FTI-TLK1 Harness Bulletin - Mis-wired Power Circuits

Overview: The initial production release of the FTI-TLK1 harness has an issue where in some vehicles the secondary power input to the CN1 connector will overload the associated vehicle circuit, causing a fuse to blow. This issue affects the initial release of harnesses and is already being addressed in production. A field correction procedure is detailed below in Figure 1.

Figure 1: Step by step adapter correction

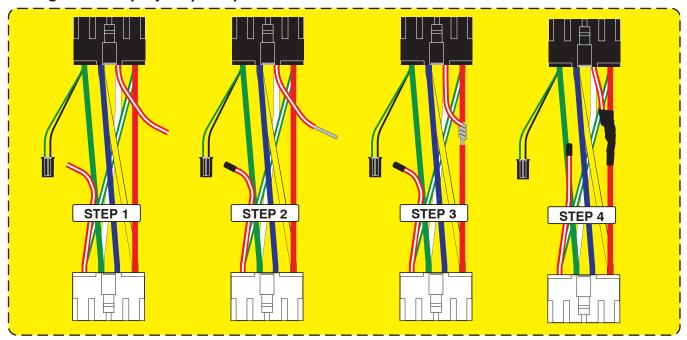
Issue: The secondary power circuit can overload some vehicle ignition switch circuits, causing a blown 5A/7.5A AM1 fuse, potentially disabling the vehicle and leaving the consumer stranded. Affected adapters are illustrated below in figure 2.

- 1.) Select the applicable CN1 adapter, isolate the RED/WHITE power wire, cut wire approximately 4" from the BLACK plug
- 2.) Insulate the wire still connected to the WHITE plug using heat shrink tubing, and strip the insulation on the other wire end
- 3.) Strip a portion of the insulation from the RED wire, attach the stripped RED/WHITE to the exposed RED wire, solder together
- 4.) Apply insulating tape to the soldered connection and secure the cut ends back to the bundle of wires created by the adapter
- 5.) Correction complete, you may safely proceed to finish your installation
